ATTN: Document Control Desk
U. S. Nuclear Regulatory Commission
Washington, DC 20555-0001**SUBJECT:****Beaver Valley Power Station, Unit No. 2
Docket No. 50-412, License No. NPF-73
Supplemental Information for Beaver Valley Power Station Unit 2 Spent Fuel Pool
Rerack License Amendment Request (TAC No. ME1079)**

Response to September 27, 2010 NRC Request for Supplemental Information

Response to September 27, 2010 NRC Request for Supplemental Information
Page 1 of 49

Figure 6-1: ANSYS Finite Element Model of Rack D4

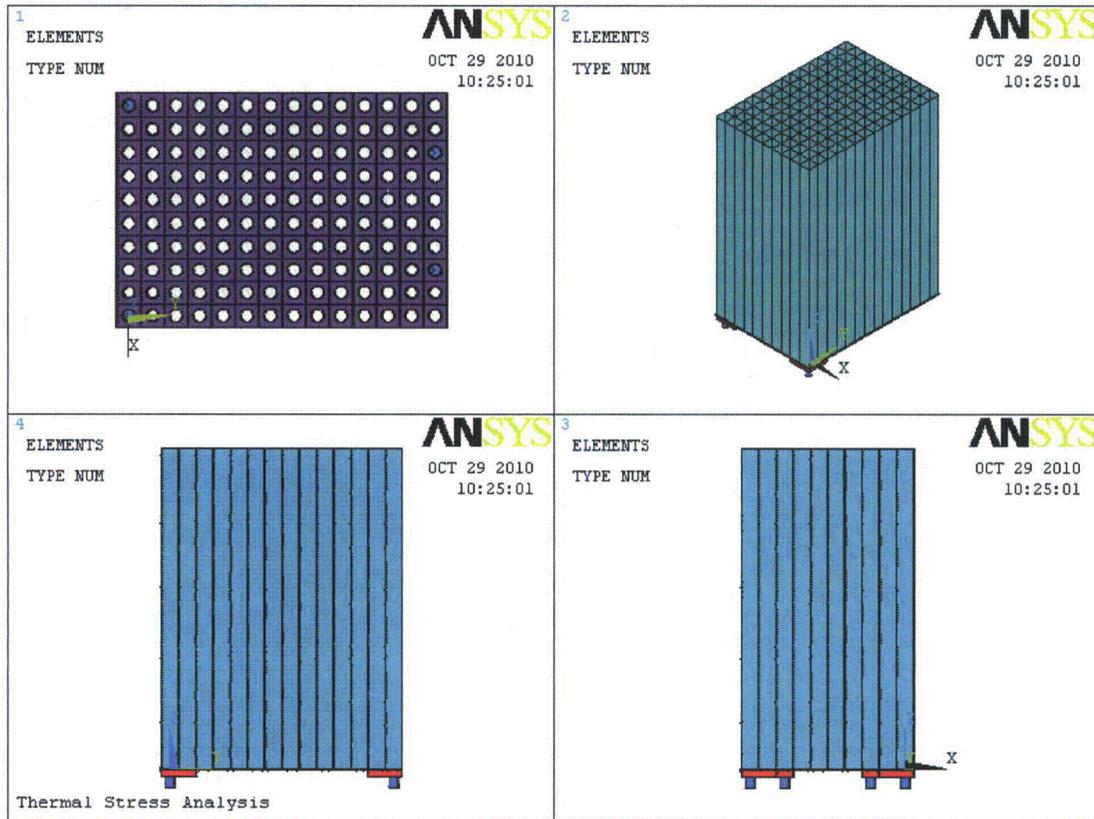
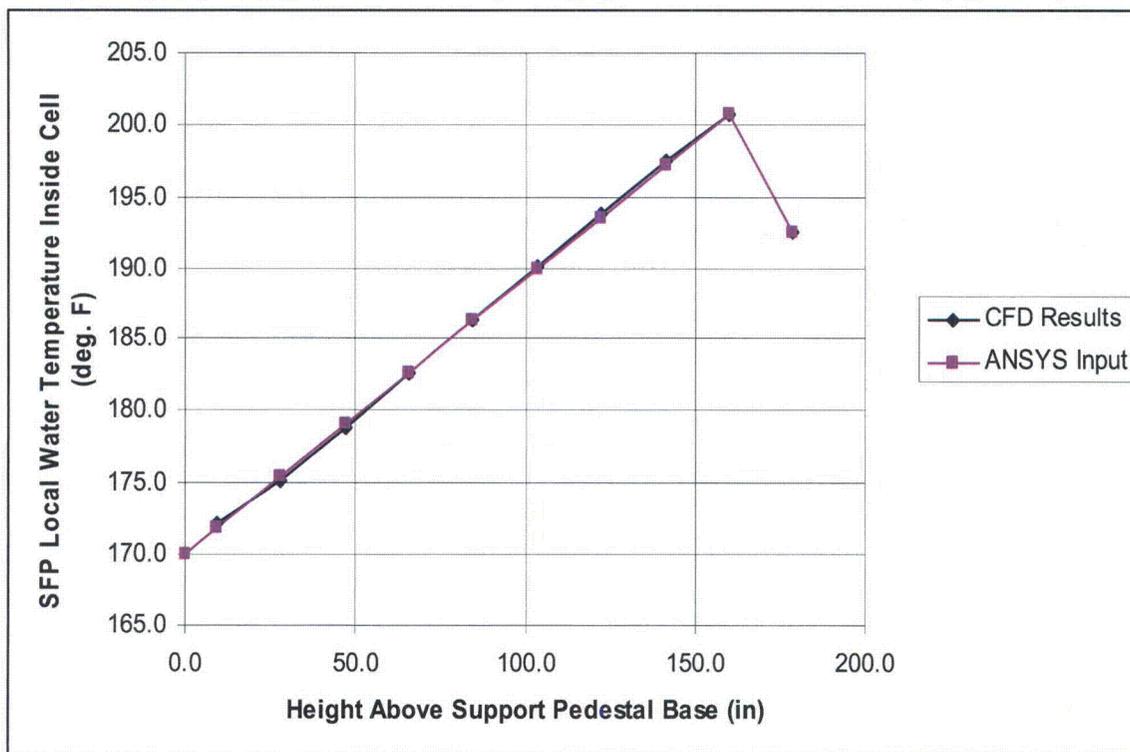
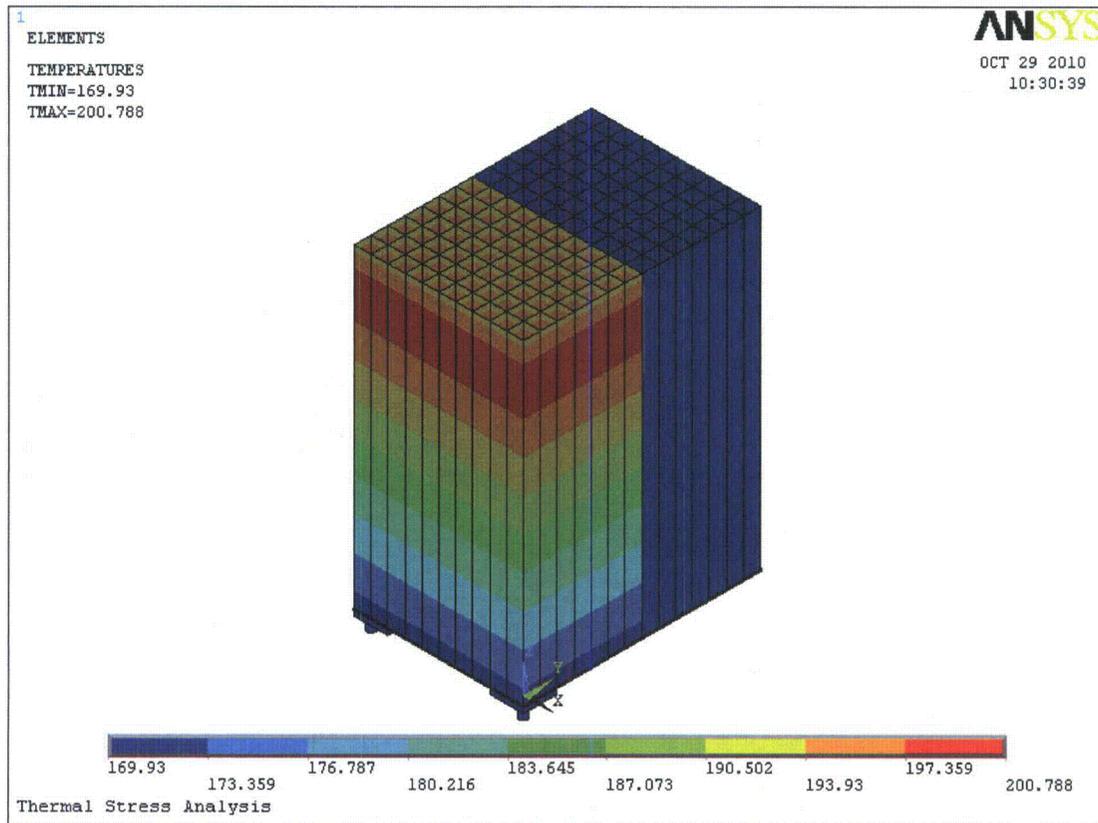
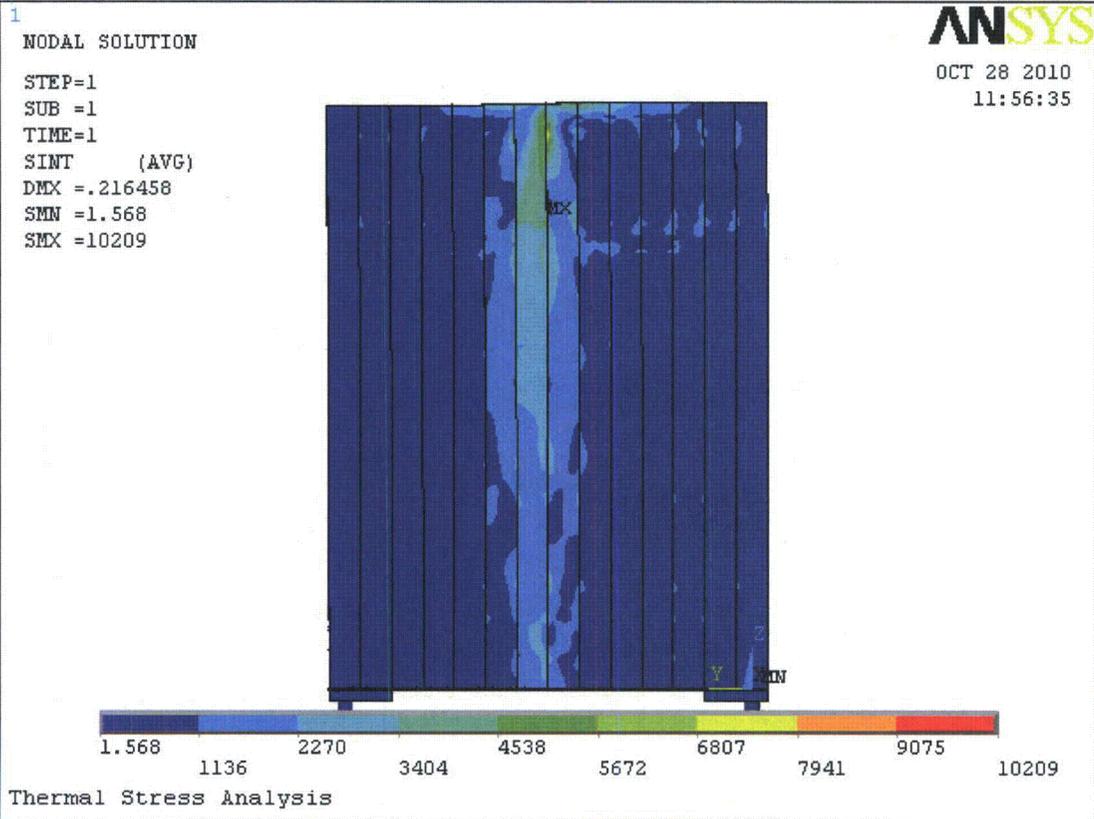
1. Appendix D to SRP 3.8.4 states that the structural acceptance criteria are those given in Table 1. OT position paper (GL 78-11) states “When subsection NF, Section III, of the ASME B&PV Code is used for the racks, the structural acceptance criteria are those given in the Table below.” The tables in the OT position paper (GL 78-11) and Appendix D to SRP 3.8.4 provide consistent guidance relative to the load combinations and corresponding acceptance limits where seismic and temperature loadings are combined.

The August 9, 2010 supplemental response discusses the shear stresses in the cell-to-cell welds due to the differential thermal growth between neighboring cells. Provide justification that the evaluation described in this response is the enveloping condition for the proposed rack design or provide supplemental information to demonstrate compliance with the guidance defined in Appendix D to SRP 3.8.4 and OT position paper (GL 78-11).

In the August 9, 2010 supplemental response, it was shown that the shear stress in the cell-to-cell welds resulting from the combined thermal and seismic stresses is less than the most restrictive acceptance limit provided in the 1978 Office of Technology (OT) position paper (Generic Letter 78-11) *Review and Acceptance of Spent Fuel Handling and Storage Applications* for thermal load combinations (that is, 1.5 times normal limits). In order to demonstrate that this is the enveloping condition for the proposed rack design, a three-dimensional finite element model of the largest spent fuel rack has been developed using ANSYS, and the thermal stresses throughout the entire rack have been solved for a bounding temperature distribution. The finite element solution confirms that the highest stressed region coincides with the cell-to-cell welds near the top of the rack where the temperature gradient between neighboring cells is at its maximum (as shown in Figure 6-4).

The ANSYS finite element model used to solve the thermal stress distribution is shown in Figure 6-1. The model accurately reflects the size and dimensions of rack D4, which is the largest of the proposed spent fuel racks for BVPS-2. The support pedestals and rack baseplate are modeled using solid elements. The cell structure, including the cell boxes, filler panels, and corner angles, are modeled using shell elements. Consistent with the rack design drawings, the weld connections are modeled in ANSYS by coupling lines of nodes between adjacent cells, between the baseplate and the cell walls, and between the baseplate and the support pedestals. The bottom surfaces of the support pedestals are fixed in the vertical direction. Finally, a constant coefficient of thermal expansion of 8.9×10^{-6} inch per inch degrees Fahrenheit (in/in-°F) is assigned to all elements in the ANSYS model. This input value conservatively bounds the mean coefficient of thermal expansion for SA-240 304L in going from 70 degrees

The applied temperature distribution for the thermal stress analysis is plotted in Figure 6-3 for the entire rack. The reference temperature used in ANSYS for thermal growth calculations is set to 70°F.

The resulting stress intensity distribution in the rack is plotted in Figure 6-4. The thermal stresses in the rack are negligible everywhere, except the boundary between the loaded and empty regions of the rack. The abrupt change in temperature across this boundary produces shear stresses in the cell-to-cell welds and tensile/compressive stresses in the adjoining cell walls. To determine the maximum shear stress in a single cell-to-cell weld, the nodal reaction forces (in three directions) have been extracted from the ANSYS solution for the topmost row of cell-to-cell welds lying on the boundary plane between the loaded and empty regions of the rack. After post-processing, the maximum resultant force acting on a single cell-to-cell weld is found to be 2,557 pounds of force (lbf); therefore, the maximum shear stress in a single cell-to-cell weld (which is conservatively treated as a 6-inch long, 1/16-inch fillet weld) is 9,644 psi. This stress is less than the weld stress (14,082 psi) originally estimated in Subsection 5.6.10.2 of the Licensing Report (Accession No.

As for the cell base metal material, the maximum calculated stress intensity anywhere in the rack structure due to the abnormal thermal load (T_a) is 10,209 psi (as shown in Figure 6-4). Conversely, for the non-thermal loads [that is, D (dead load) + L (live load) + either E (operating basis earthquake [OBE] load) or E' (safe shutdown earthquake [SSE] load)], the maximum stress occurs at the base of the perimeter cells since the cell structure above the base plate acts like a cantilevered beam under horizontal seismic loading. From the DYNARACK simulations, the maximum combined flexure plus tensile/compressive stress due to SSE loading ($D + L + E'$) is 9,381 psi. Notwithstanding the fact that the maximum thermal and seismic stresses occur at opposite ends of the rack, if the two maximums are summed together, the result is 19,590 psi, which is less than the yield strength of SA-240 304L material at 200°F (21,300 psi). Per the January 19, 1979 amendment to the OT position paper, the acceptance limit for load combinations involving thermal loads is the "lesser of $2S_y$ (yield stress) or S_u (ultimate tensile stress) stress range." For SA-240 304L, $2S_y$ [42.6 thousand pounds per square inch (ksi)] is less than S_u (66.2 ksi); therefore, the acceptance limit is $2 \times 21,300$ psi = 42,600 psi. Since this value is more than two times the maximum combined thermal plus seismic stress (19,590 psi), the calculated stresses in the proposed spent fuel racks for BVPS-2 comply with the acceptance limit provided in the OT position paper (including the January 19, 1979 amendment). The preceding evaluation bounds all load combinations involving thermal loads from the OT position paper since it conservatively combines the seismic stresses due to SSE loading (E') with the thermal stresses due to an abnormal full core offload (T_a), and it compares the result with the acceptance limit for non-faulted conditions (lesser of $2S_y$ or S_u stress range).

Figure 8-1: ANSYS Finite Element Model of SFP East Wall Under Uniformly Distributed Pressure Load

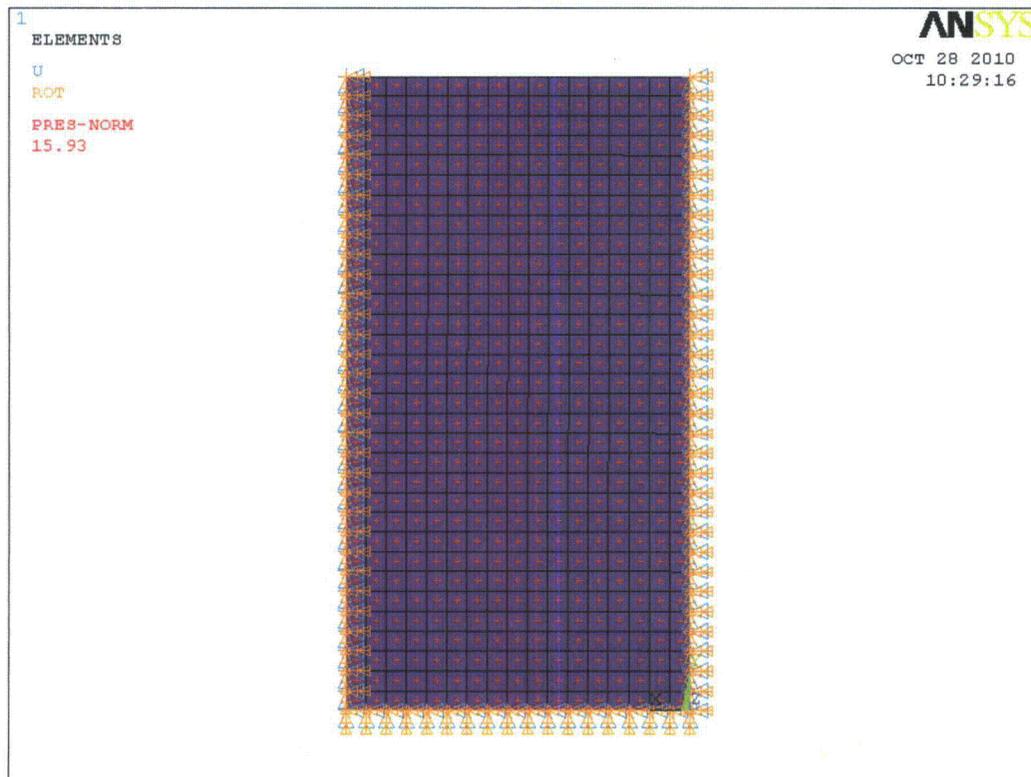
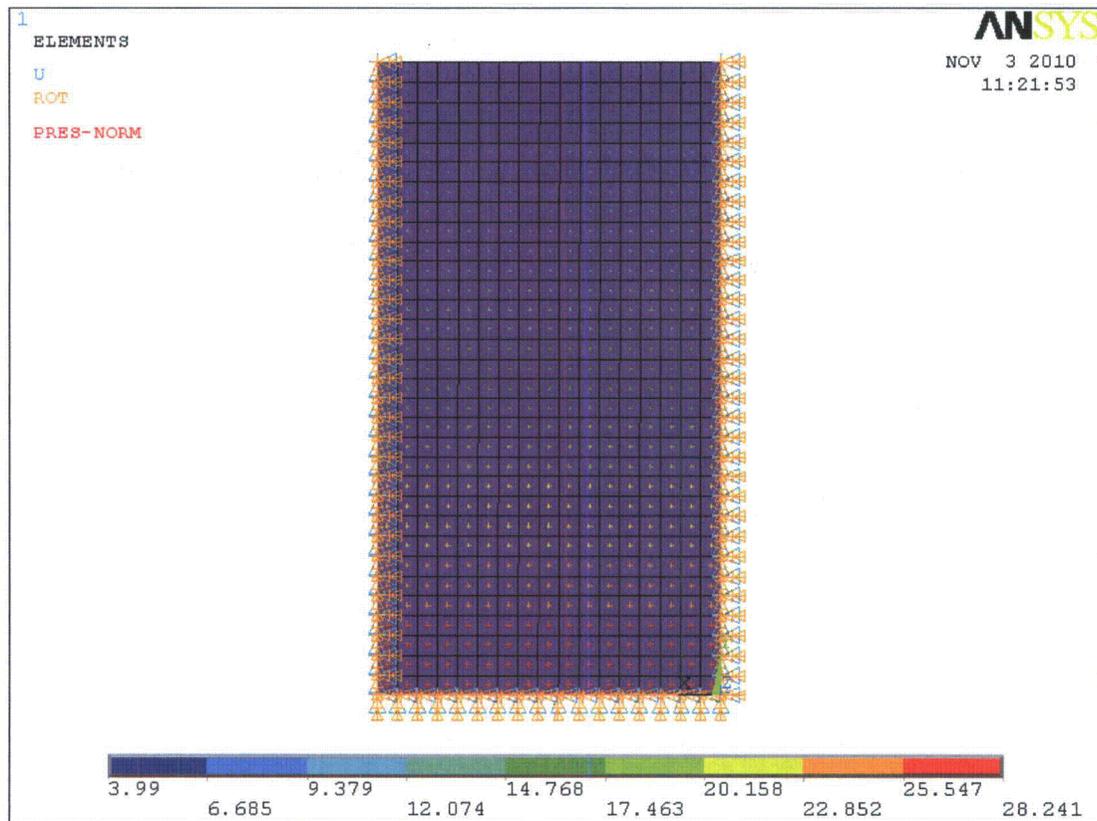
3. Provide further justification that the tributary area methodology used in one-way shear evaluation is conservative.

To validate the tributary area methodology and quantify the degree of conservatism associated with the one-way shear evaluation, a simple finite element model of the SFP east wall (which is limiting based on the one-way shear evaluation presented in the August 9, 2010 supplemental response) has been created in ANSYS and analyzed for two different pressure load cases. The finite element model resultant shear forces on the wall are then compared with the results obtained using the tributary area methodology. The following paragraphs describe the ANSYS model, the load cases analyzed, and the results.

The finite element model, shown in Figure 8-1, is comprised entirely of shell elements. The height, width, and thickness of the SFP East Wall are modeled in ANSYS as 486 inches, 263.5 inches, and 24 inches, respectively. Consistent with the one-way shear evaluation, the top edge of the wall is assumed to be free and the other three edges are fixed. In the first load case, a uniform pressure of 15.93 psi (which equals the total out-of-plane load on the SFP east wall due to the load combination 1.4D + 1.9E) is applied over the entire face of the wall, and the nodal reaction forces are summed along each of the three fixed edges to determine the shear force distribution. The following table compares the calculated shear forces on the fixed edges of the wall as obtained from ANSYS and from the tributary area method.

The ANSYS results and the results obtained using the tributary area method show excellent agreement confirming that the tributary area method (as presented in the August 9, 2010 supplemental response) is a valid method for distributing a uniformly distributed (out-of-plane) load on a wall to its support edges.

In the second load case, a linear varying pressure load is applied to the same model to reflect the precise loading on the SFP east wall due to the load combination 1.4D + 1.9E (which are the limiting SFP wall and load combination from the one-way shear evaluation). In other words, instead of applying a uniform pressure of 15.93 psi over the entire wall, a linear varying pressure is applied to the wall, which has a minimum value of 3.99 psi at the top edge of the wall and a maximum value of 28.24 psi at the bottom edge of the wall (as shown in Figure 8-2). The following table compares the calculated shear forces on the fixed edges of the wall as obtained from ANSYS versus the one-way shear forces evaluated for the August 9, 2010 supplemental response, which are estimated using the tributary area method.
